SUBMITTAL IDENTIFICATION SHEET

WEBSTER UNIVERSITY ISB
PROJECT NAME

123553-001 REV 2
CONTRACTOR / CM SUBMITTAL NO.

12 3553-001 REV003
CANNON DESIGN SUBMITTAL NUMBER

FOOT MASTER ®	FOOMA ®	G-DOK IND.	MODEL NAME	GD-60-S

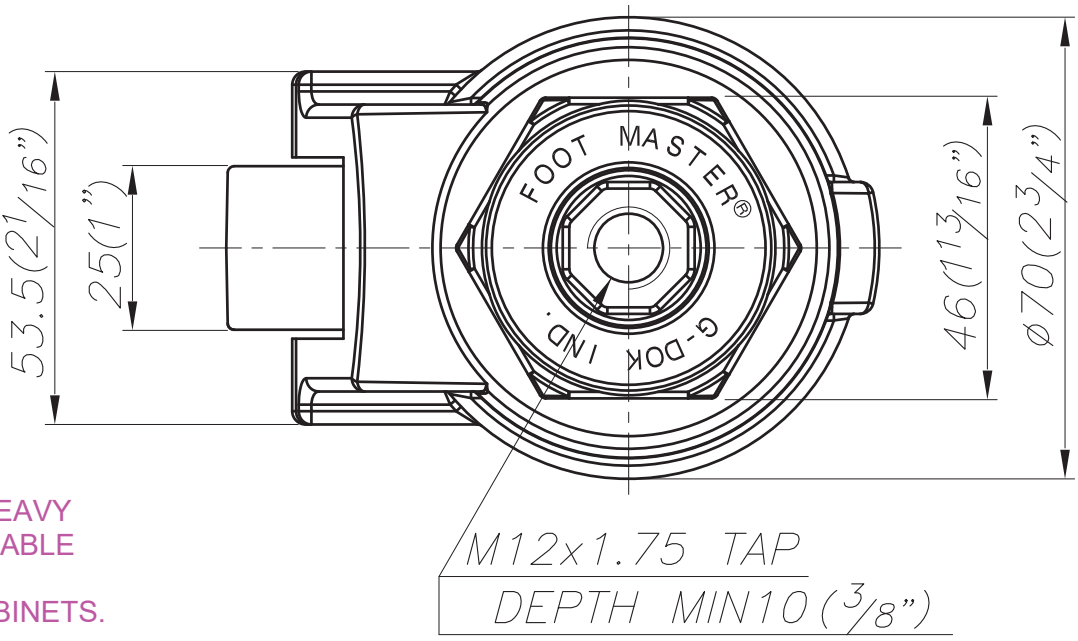
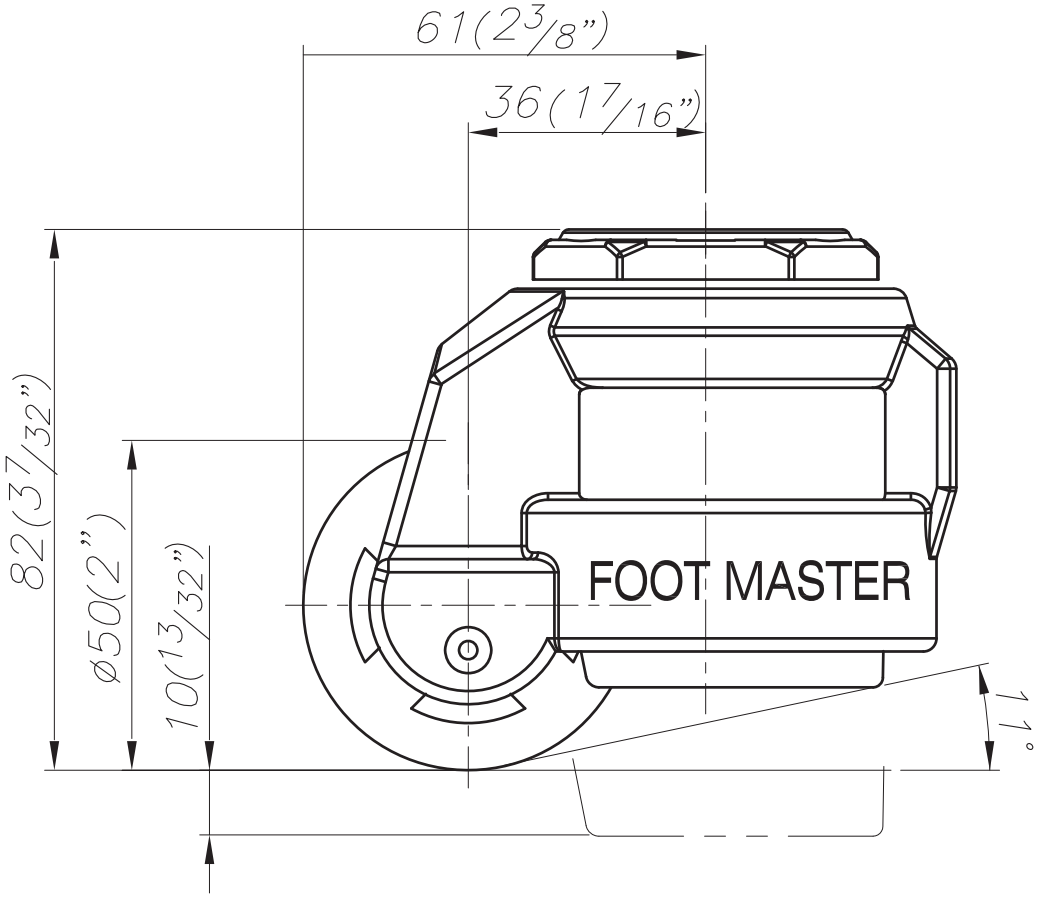
HEAVY DUTY LEVELING CASTER
LOCATED AT MOBILE STATIONS, ~~MOBILE CABINETS~~ & MOBILE TABLES.

PROVIDE HEAVY DUTY LOCKABLE CASTER AT MOBILE CABINETS.
